PROJECT NAME: CHILDERS ROAD SUBDIVISION, DRAWING TITLE: ZONING PLAN, PROJECT NO.: Z-01, WFO PROJ. NO.: 20143003.00 AT.

**PETITION NO:** Z-17

# Z-17

**ZONING COMMENTS:**

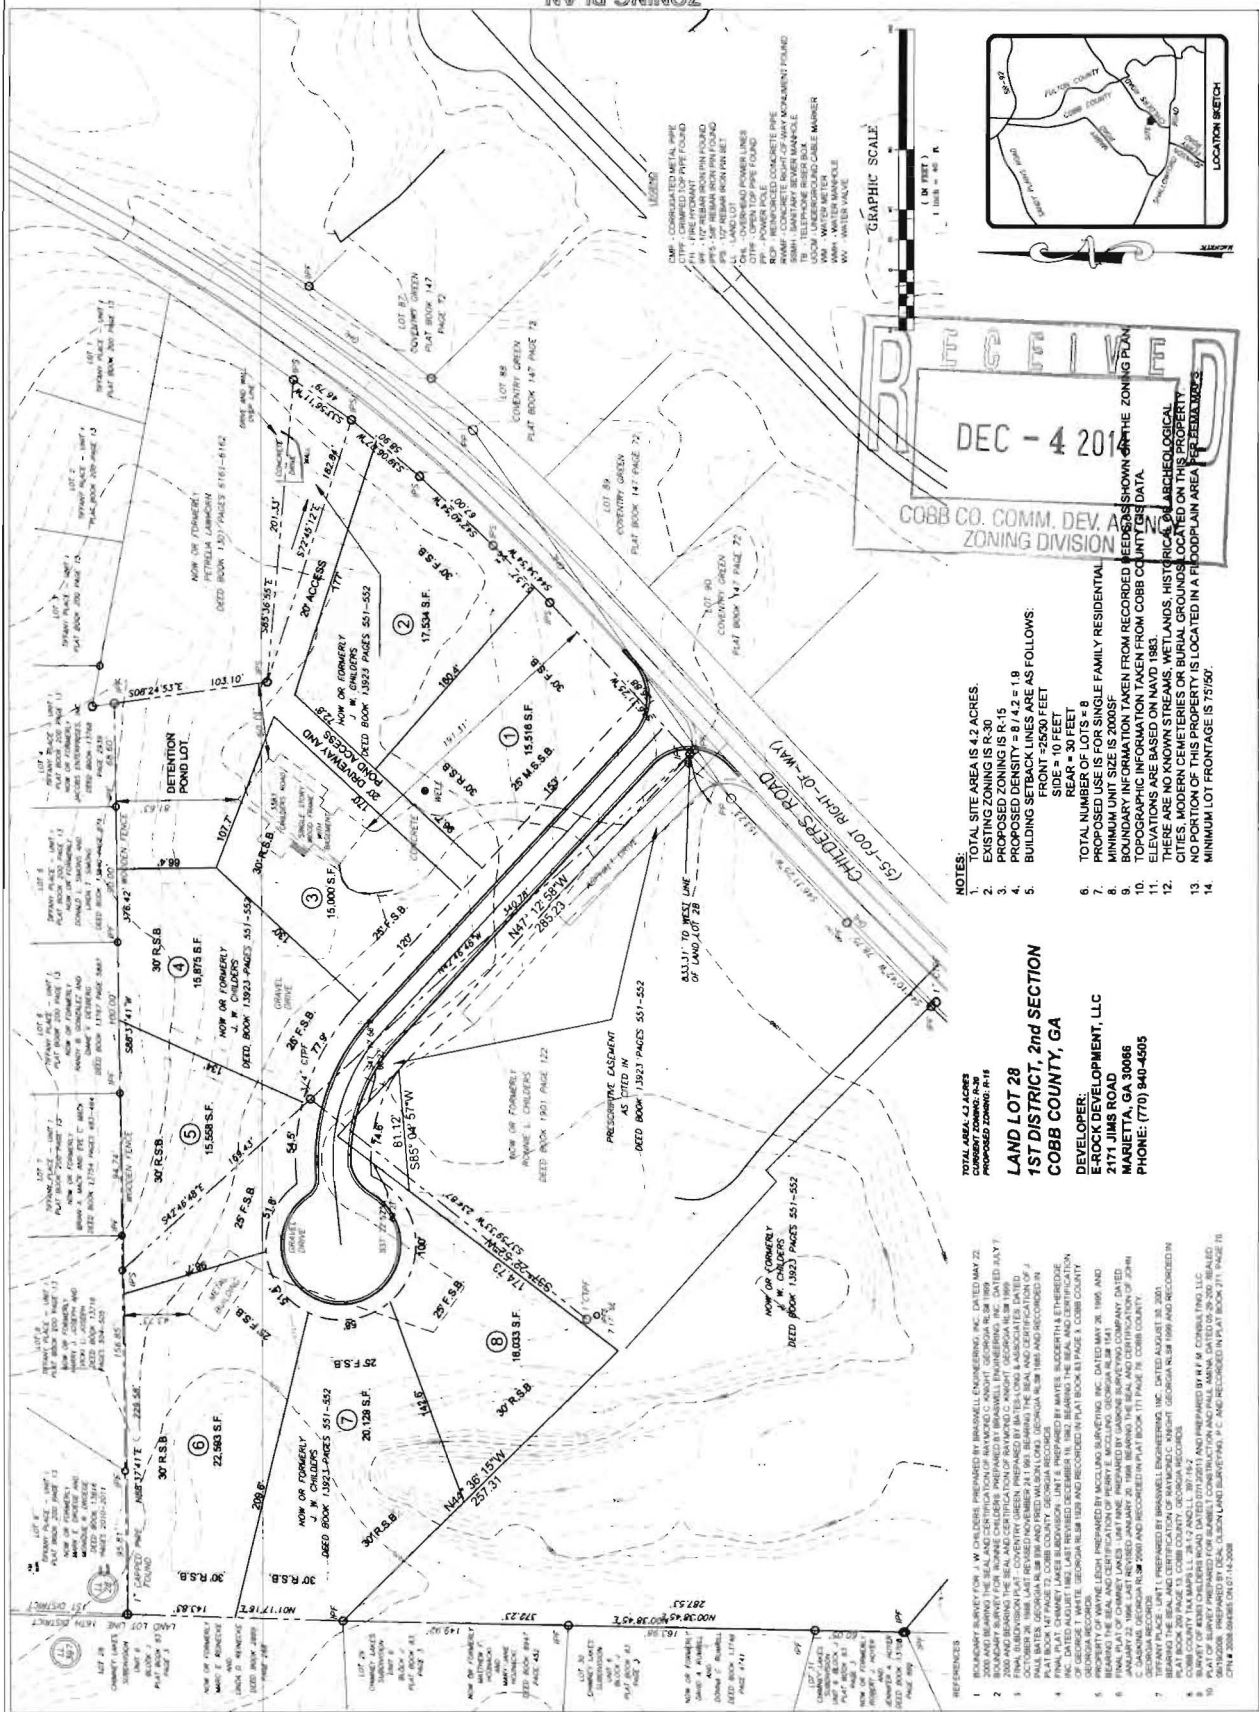
The applicant is requesting a rezoning to the R-15 single-family residential zoning district in order to develop an eight (8) lot subdivision. The homes' sizes will be 3,200 square feet and greater. The proposed architecture is traditional and craftsman with anticipated selling prices in the \$800,000s. As presented, the applicant is requesting a waiver of the front setbacks from the required 35 feet to 25 feet for lots 3 through 8 and from the required 35 feet to 30 feet on lots 1 and 2.

Additional Sewer easement in Tiffany Place lots 5 and 6 extends to property line  
Comments:

1. This site is located just northwest of Childers Road. Average slopes are relatively flat to moderate with maximum of 15%. The site cover is a mixture of open and wooded areas. The majority of the site (2/3) drains to the north into Tiffany Place Subdivision. The rear third drains into the Chimney Lakes Subdivision.
2. The detention facility must be tied directly to the existing downstream system within Tiffany Place S/D (Lot 4). The current channel conveyance through this lot does not have adequate capacity to handle the proposed increased runoff volume.
3. The majority of lots 6-8 will naturally bypass the detention pond. A drainage easement will be required at the rear of lots 4-6 to convey site runoff to the pond. Grading or landscape walls will likely be required to direct all impervious lot runoff to this easement.

Childers Road is classified as a minor collector and according to the available information the existing right-of-way does not meet the minimum requirements for this classification.

Recommend applicant verify that minimum right-of-way is available for Childers Road and if it is not, recommend applicant consider entering into a development agreement pursuant to O.C.G.A. 36-71-13 for dedication of the following system improvements to mitigate traffic concerns: a) donation of right-of-way on the west side of Childers Road, a minimum of 30' from the roadway centerline.

Recommend taper for the Childers Road access.

Recommend no driveways access Childers Road.

Recommend curb, gutter, and sidewalk along the Childers Road frontage.

- Site plan received by the Zoning Division on December 4, 2014 within District Commissioner approving minor modifications;
- Fire Department comments and recommendations;
- Sewer and Water Department comments and recommendations;
- Stormwater Management Division comments and recommendations;
- Department of Transportation comments and recommendations; and
- Owner/developer to enter into a Development Agreement pursuant to O.C.G.A. §36-71-13 for dedication of system improvements to mitigate traffic concerns.
